**CULTURAL RESOURCES OFFICE
 PRESERVATION BOARD
 REGULAR MEETING
 MONDAY APRIL 28, 2014 — 4:00 P.M.
 1520 MARKET ST. #2000
www.stlouis-mo.gov/cultural-resources**

DATE: April 28, 2014
ADDRESS: 1315 Dolman Street
ITEM: Preliminary Review: New construction, single-family house.
JURISDICTION: Lafayette Square Certified Local Historic District — Ward 6
STAFF: Bob Bettis, Cultural Resources Office

DATE: April 28, 2014
ADDRESS: 4100 and 4018 Lindell Blvd.
ITEM: Demolish 4108 Lindell and rehabilitate 4100 Lindell.
JURISDICTION: 4100-4300 Lindell Local Historic District — Ward 17
STAFF: Betsy Bradley, Cultural Resources Office

SOUTH FACADE

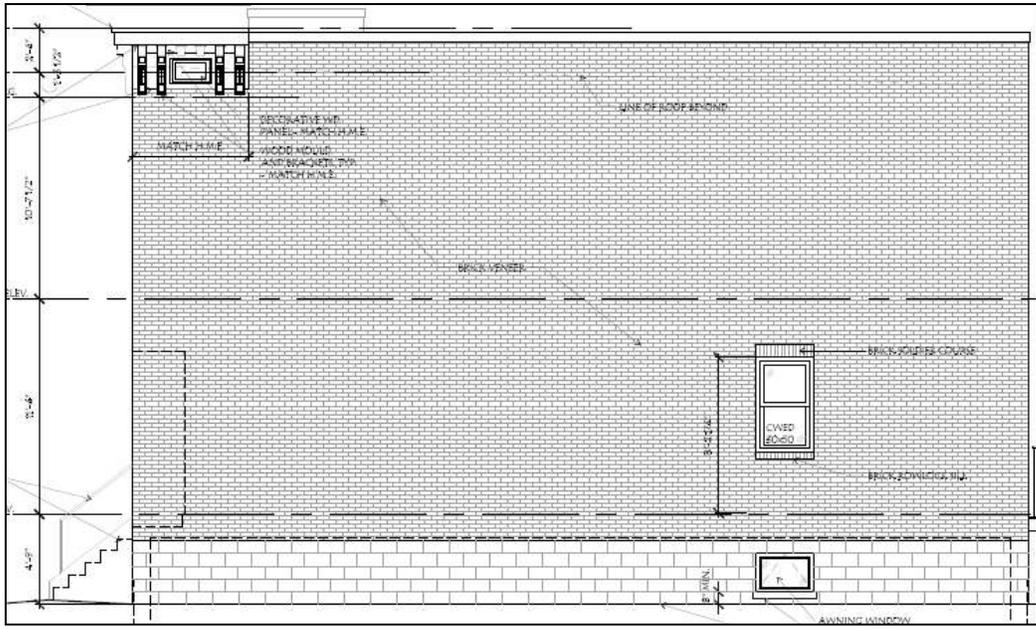
Does not comply. The first bay of windows on the south façade sits too close to the front of the building displaying an appearance that would not have occurred historically.

PROPOSED SITE PLAN

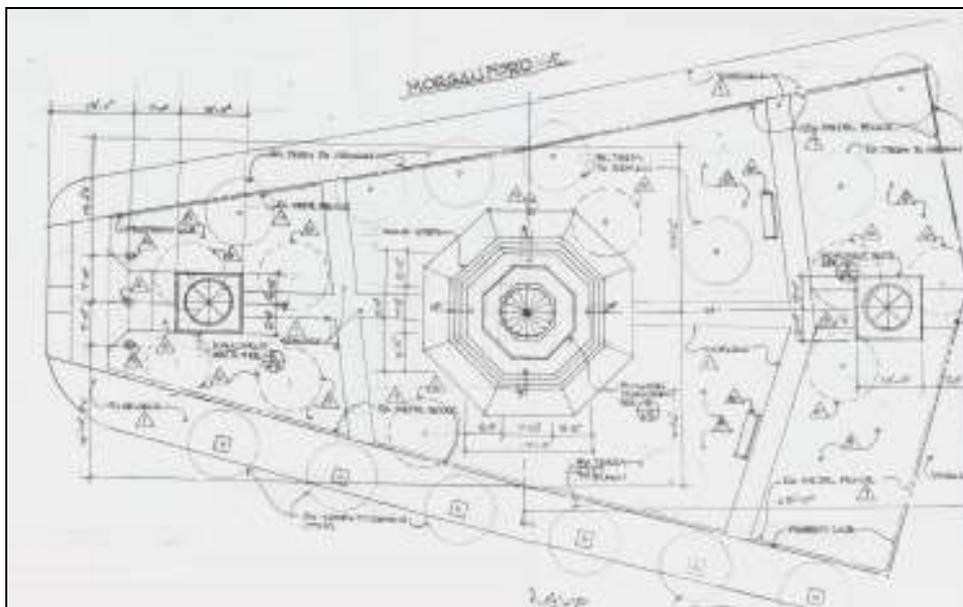
- The proposed site is a recently-acquired, minimally-improved city park, with no permanent structures.
- The site is directly south of Bevo Mill and the Bevo Mill Commercial District National Register District but at some distance beyond a large intersection, and therefore will have minimal impact upon these historic resources.
- The proposed structures, while tall, are of a scale that appears appropriate for the park site.

Based on the Preliminary findings, the Cultural Resources Office recommends that the Preservation Board direct the Office to convey a recommendation to the Board of Public Service that, given the size of the park, which is only minimally improved at present, and its location directly opposite Long Middle School, a building of considerable scale and height, that the proposed improvements are appropriate.
